Model: Pomelo-P3	Date: 06-Nov-01	No.: RG063001a
------------------	-----------------	----------------

Subject: Firmware History - MCTL		Prepared by: H.K.	
From: Technical Services Dept., GTS Division			
Classification:	<input type="checkbox"/> Troubleshooting <input type="checkbox"/> Mechanical <input type="checkbox"/> Paper path <input checked="" type="checkbox"/> Other (Firmware History)	<input type="checkbox"/> Part information <input type="checkbox"/> Electrical <input type="checkbox"/> Transmit/receive	<input type="checkbox"/> Action required <input type="checkbox"/> Service manual revision <input type="checkbox"/> Retrofit information

Model: Pomelo-P3		Date: 11-Dec-01	No.: RG063002
Subject: Firmware History - RPS2&Printer Control Board		Prepared by: H.K.	
From: Technical Services Dept., GTS Division			
Classification:	<input type="checkbox"/> Troubleshooting <input type="checkbox"/> Part information <input type="checkbox"/> Action required <input type="checkbox"/> Mechanical <input type="checkbox"/> Electrical <input type="checkbox"/> Service manual revision <input type="checkbox"/> Paper path <input type="checkbox"/> Transmit/receive <input type="checkbox"/> Retrofit infor

Fig. 1: Grease Removal

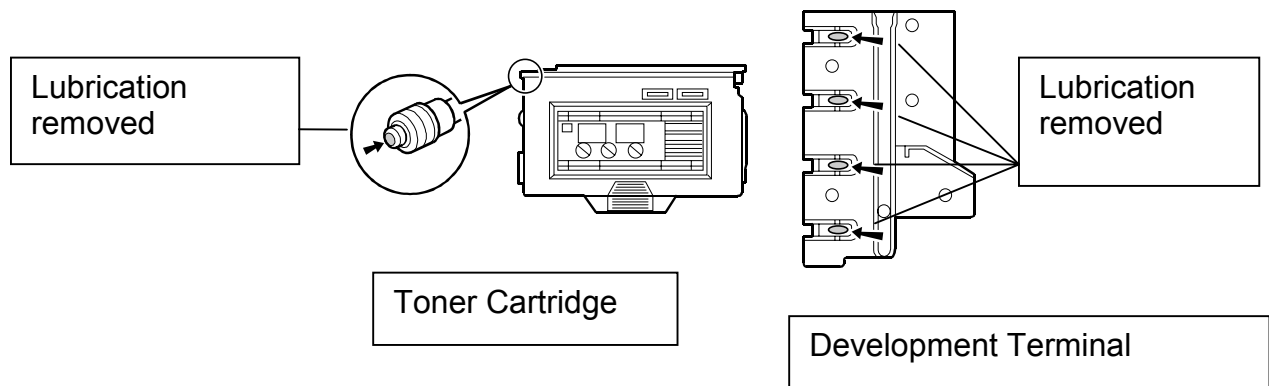
1. Lubricant (grease) will no longer be applied to the toner cartridge terminal and the development bias terminal (see Fig. 1 on the next page).
2. The shape of the left development unit guide has been changed to minimize the possibility of foreign particles being generated from the guide scratching the toner cartridge (see Fig. 2 on the next page).

Clean the development bias terminal, toner cartridge terminal, and left development unit guide to remove any foreign material.
